Technical Service Bulletin

91 MMI3G+ GPS navigation location inaccurate or navigation takes a very long time to acquire location

91 15 22 2040406/4 October 16, 2015. Supersedes Technical Service Bulletin Group 91 number 15-10 dated August 25, 2015 for reasons listed below.

Figure 2. Example of integrated circuit chip without coating (left) and with coating (right). Parts without the coating over the integrated circuit chip are not okay and should be replaced.

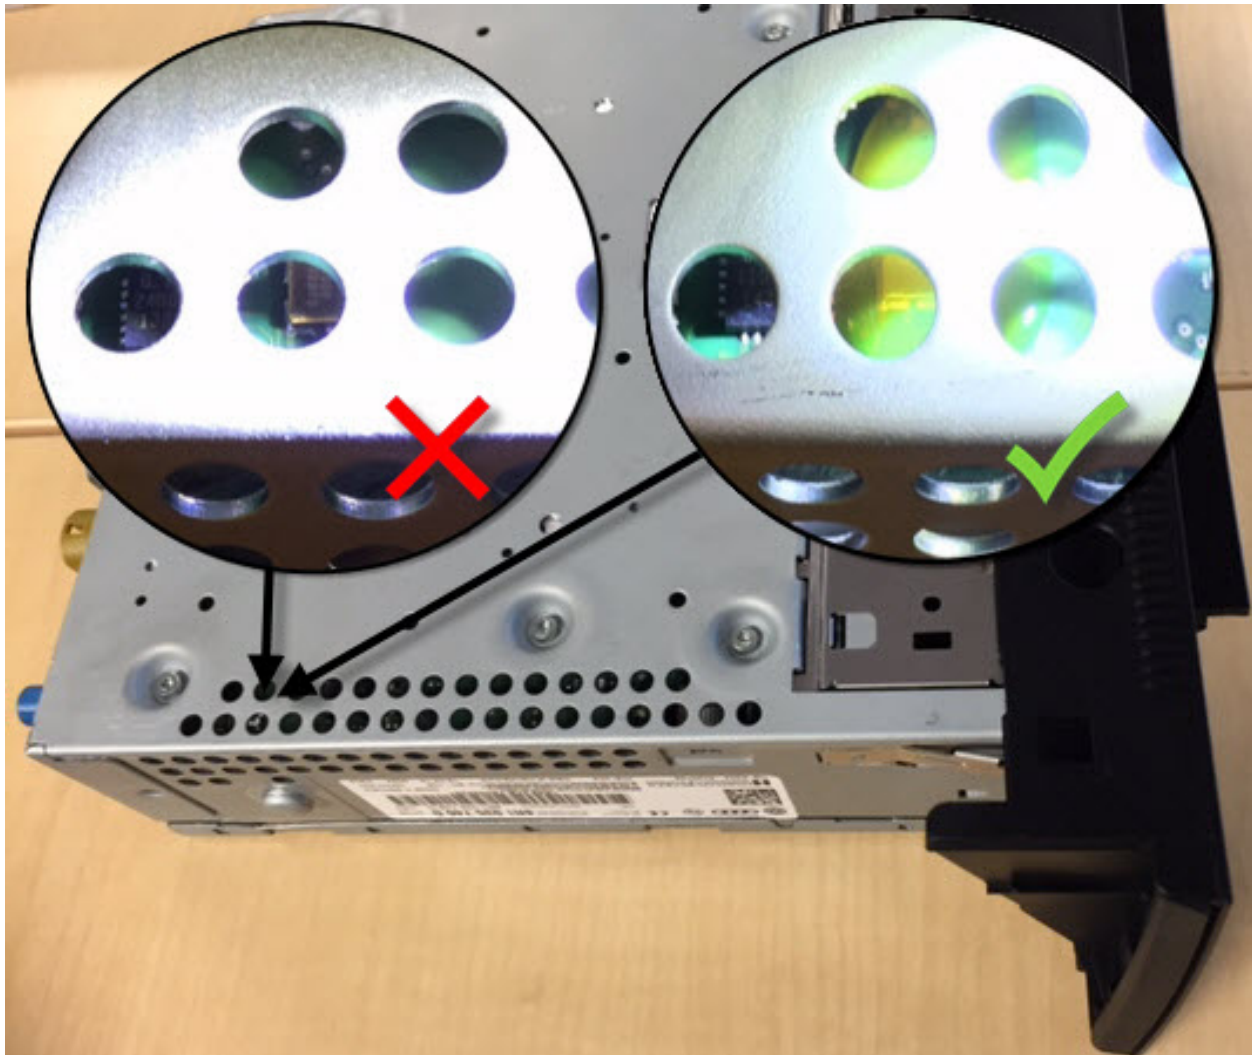
3. Order a replacement MMI main unit using the applicable part number listed in the parts table below. There are different variants of main units that have support for a SIM card slot and some variants that do not. Once the new part arrives, check the integrated circuit chip of the GPS oscillator on the internal circuit board. The chip should have a translucent yellow coating (Figure 2).

Some early service parts did not have the coating despite the updated hardware part number (G suffix) and build date. All parts built after November 08, 2014 should have the coating over the integrated circuit chip. If the part does not have the coating over the integrated circuit chip, return the part and order a replacement.

If the parts department has problems getting updated parts with the integrated circuit chip coating, contact TAC. A small amount of specially modified parts are available for shipping directly from Audi of America.
